Technical Service Information

THM 3T40 (125C) RATTLE OR CLICKING NOISE

Figure 1

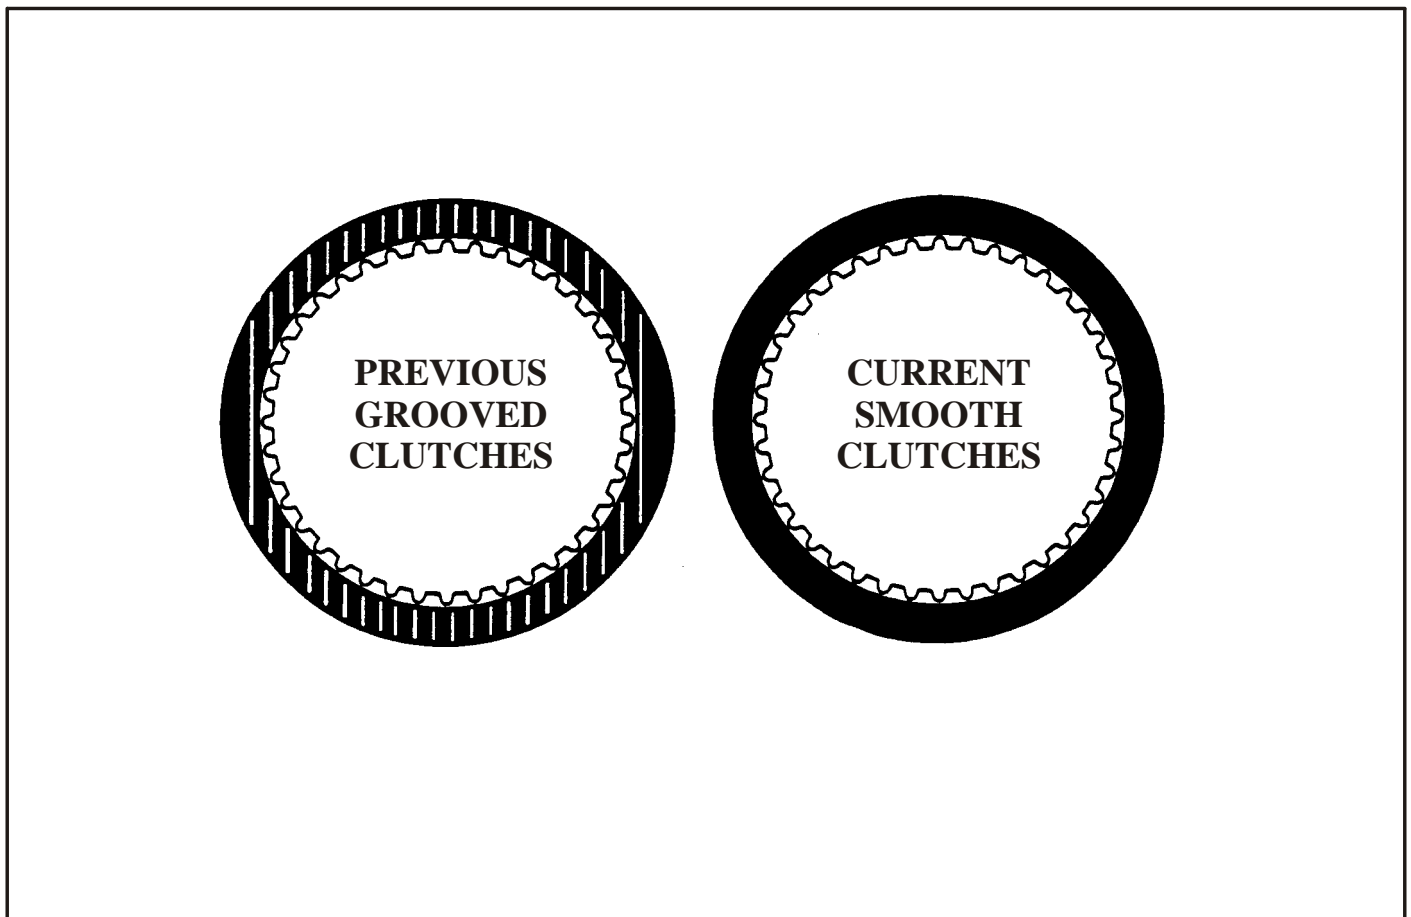
COMPLAINT: An intermittent rattle and/or clicking noise that is most evident in 3rd gear.

CAUSE: The noise may be caused by 'Grooved' lo-reverse lined clutch plates (See Figure 1).

CORRECTION: Install 'Smooth' lo-reverse lined clutch plates, available under OEM Part No. 8666667 the new clutch plates went into production May 5, 1989 (Julian Date 125).
